Imray Correction Notice ICA24-3

Chart A24 WGS 84

Edition 2016

Block correction for A24 (Plan G) ILNW 582/19

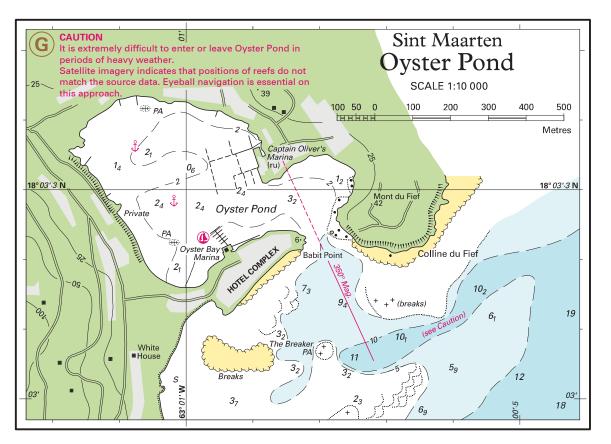
Main chart Delete RW safewater spher. Lt buoy PA in 18°03'·15N 63°00'·43W Plan G Insert accompanying block correction centred on 18°03'·25N 63°00'·83W (Street 2019) (ILNW 582/19)
